A CUMMINS FIELD CAMPAIGN

Subject: ISX CM871 ReCon Engine Control Module Safety Campaign

Number: C2253

Date: 24-Jan-2020

Figure 1 - Location of ECM Serial Number

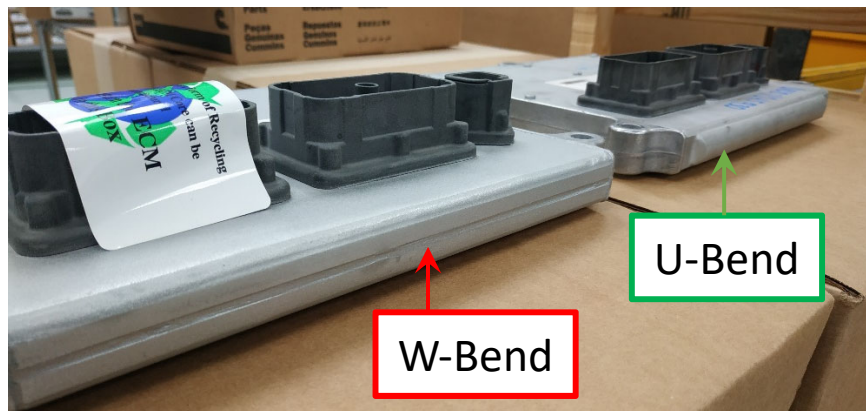
Check the serial number of any remanufactured ECMs Part Number 3684275RX in your inventory to identify any ECMs having a serial number with a prefix of A or B. See **Figure 1** to locate the serial number. To assist you in identifying these ECMs, those having a serial number with a prefix of A or B have a “W-Bend”. ECMs having a serial number with a prefix of C (not included in the recall) have a “U-Bend”. See **Figure 2** below to distinguish between the two.

If you find any ECMs having a serial number with a prefix of **A** or **B**, follow the Return Goods Process under **CSCO-Alert-2019-0030**.

Figure 3 – Location of ECM on Engine

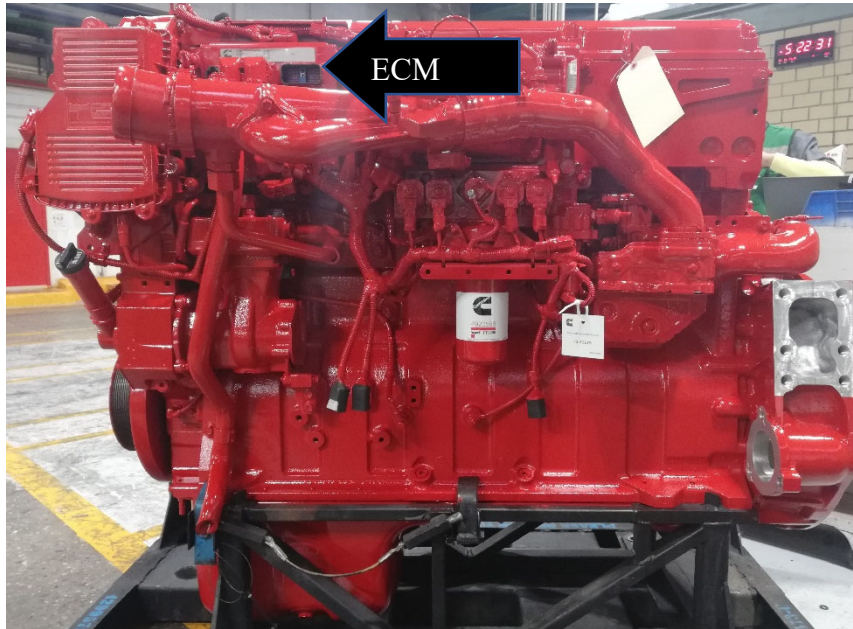
Also check any of the remanufactured engines in your inventory having the part numbers identified above to identify if any of them contain any ECMs having a serial number with a prefix of A or B. See **Figure 3** for the location of the ECM on the engine and **Figure 4** for the location of the ECM serial number.

If you find any ECMs having a serial number with a prefix of **A** or **B** on the Recon Engines, or on customer owned units, follow the instructions in detailed in Safety Campaign #2253 "ISX CM871 Engine Control Module Safety Campaign".
